SERVICE BULLETIN

SB-AG-74

**HARTZELL PROPELLER, INC.
SERVICE LETTER HC-SL-61-366
Propeller – NYCO GN3058 Grease**

HARTZELL PROPELLER INC.
SERVICE LETTER
HC-SL-61-366
Propeller - NYCO GN3058 Grease

Lubrication Label
Figure 1

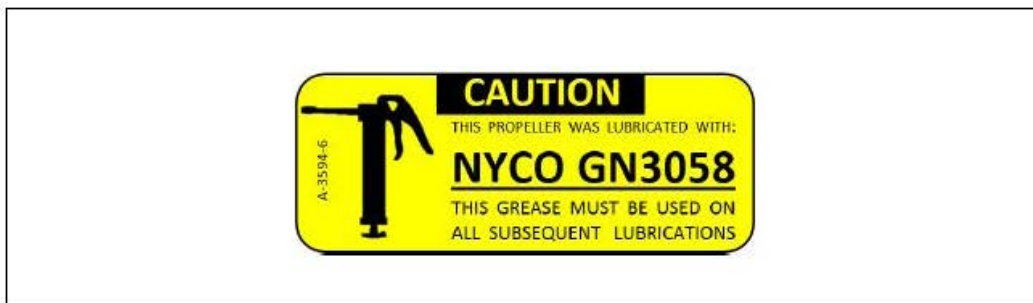
- (1) Hartzell Propeller Inc. is introducing NYCO GN3058 as the preferred grease for use in the affected propellers.
 - (a) Affected propellers manufactured by Hartzell Propeller Inc. after the release date of this Service Letter will be lubricated with NYCO GN3058 grease.
 - (b) The label shown in Figure 1 will be applied to propellers lubricated with NYCO GN3058 grease by Hartzell Propeller Inc.

- (1) This Service Letter provides Additional Maintenance Information (AMI).
- (2) This Service Letter introduces NYCO GN3058 as the preferred grease for affected propellers manufactured by Hartzell Propeller Inc.
- (3) This Service Letter introduces a revised version of the A-3594-6 lubrication label used on Hartzell propellers.
 - (a) The revised version of the A-3594-6 lubrication label is yellow and specifies NYCO GN3058 grease. Refer to Figure 1.
 - 1 The previous version of the A-3594-6 lubrication label specified Aeroshell 6 grease.
 - (b) Contact Hartzell Propeller Inc. to replace existing inventory of A-3594-6 lubrication labels
